UNITED STATES PATENT AND TRADEMARK OFFICE

APPLICATION NO.	FILING DATE	FIRST NAMED INVENTOR	ATTORNEY DOCKET NO.	CONFIRMATION NO.
10/820,207	04/08/2004	David Alan Benner	BENNER-1	7438

Office Action Summary

DETAILED ACTION

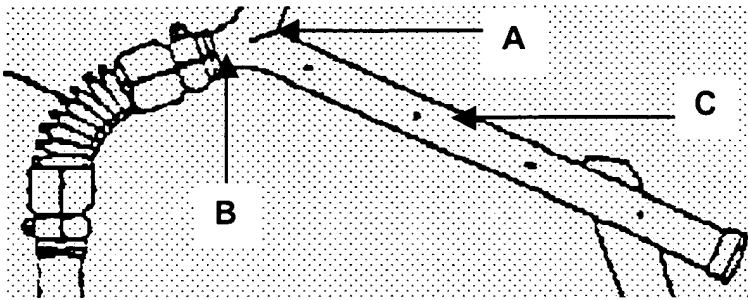
a plurality of canopy support brackets **3a** that are supported by the vertical posts, each canopy support bracket having a first end, a second end and an apex point **A** (Figure 3 reprinted below with annotations) deposited between the first end and the second end, wherein an ascending section **B** exists between the first end and the apex point, and a descending section **C** exists between the apex point and the second end;

As to claim 2, D'Ath discloses a system wherein the first end of the canopy support brackets **3a** selectively interconnect with the top end the vertical posts **3b**, whereby the canopy support brackets are supported above the vertical posts (Figure 3).

As to claim 3, D'Ath discloses a system wherein the ascending section **B** and the descending section **C** of each canopy support bracket **3a** is straight (Figure 3).

erecting a plurality of supports **3b** along a periphery to be fenced, wherein each of the supports has a vertical section **3b**, an ascending section **B** that extends at an angle above the vertical section to an apex point **A**, and a descending section **C** that extends downwardly from the apex point to free end;

attaching a canopy support bracket **3a** to each of the posts, wherein each the canopy support bracket embodies the ascending section **B** and the descending section **C** of each the support (Figure 3).
